TOWN OF WILTON
ADDENDUM NO. 2

RFP #2022-09

**Request for Proposal to Replace Lovers
Lane Bridge - Bridge #04975**

ADDENDUM NO. 2

ADDENDUM NO. 2
 DRAWING NO. S-10
 SHEET NO. 04.10.A3

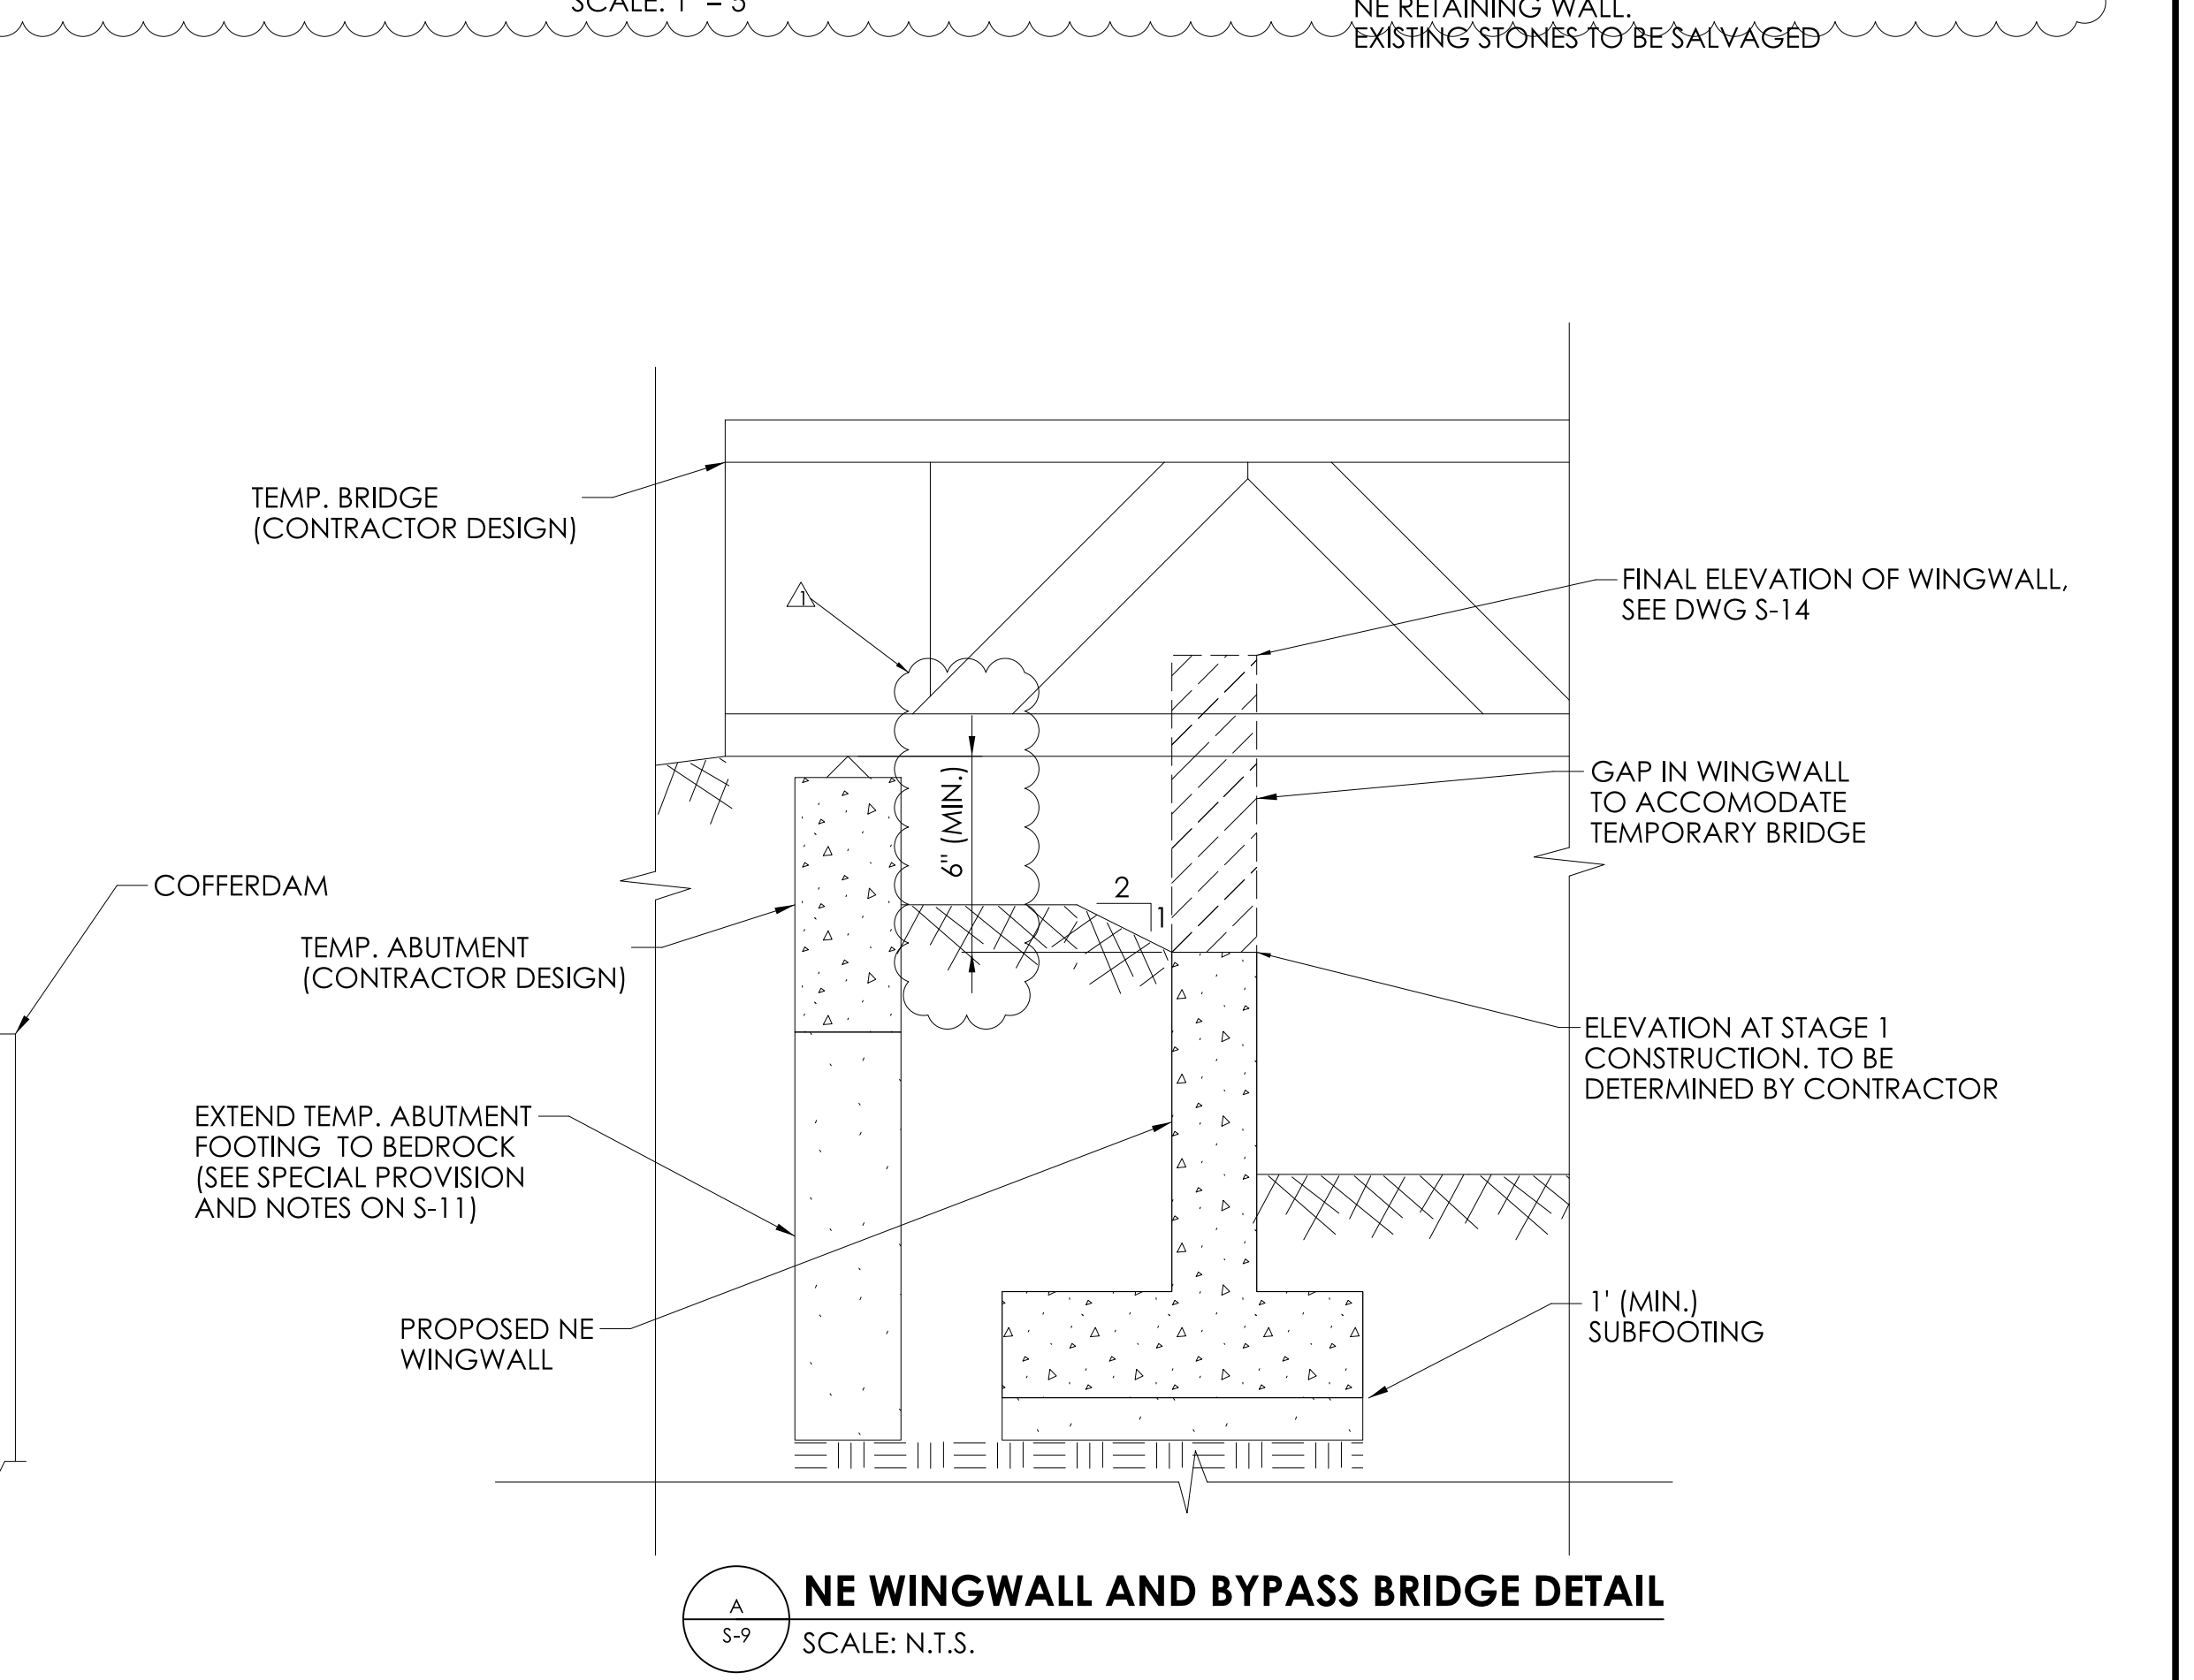
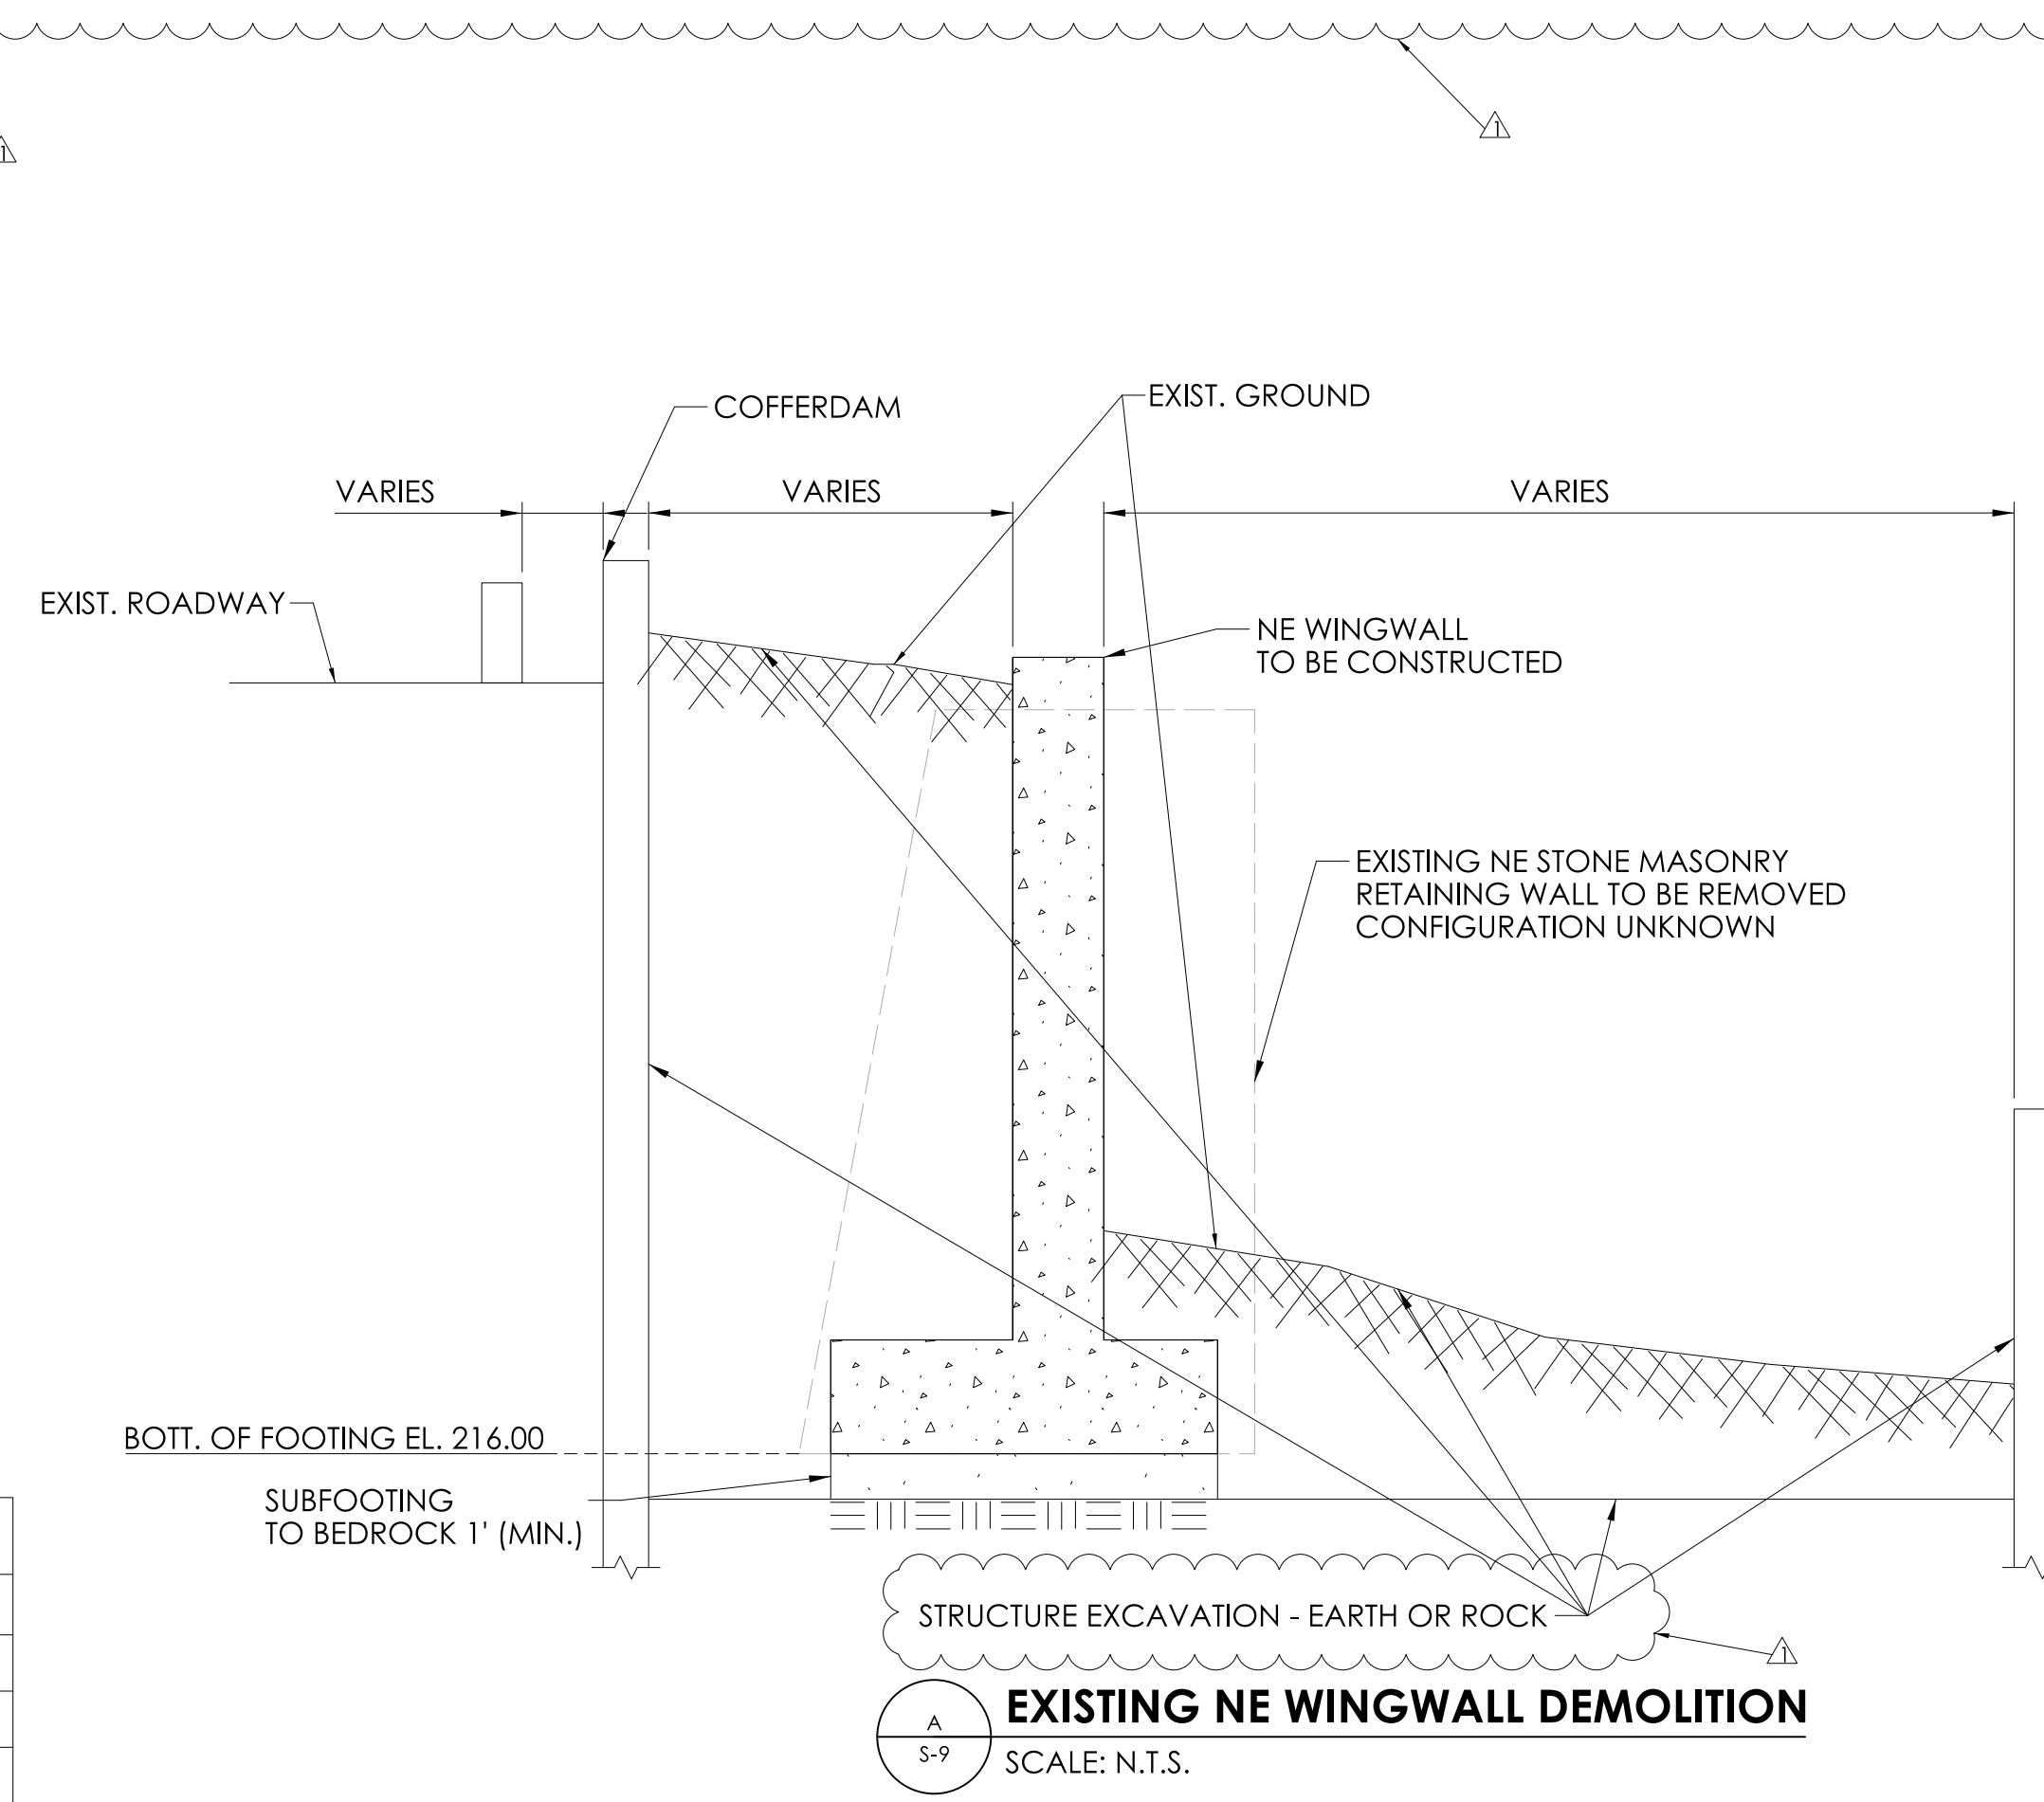
REV.	DATE	NOTE CHANGE & ADDED CALLOUTS	REVISION DESCRIPTION
1	12/15/22
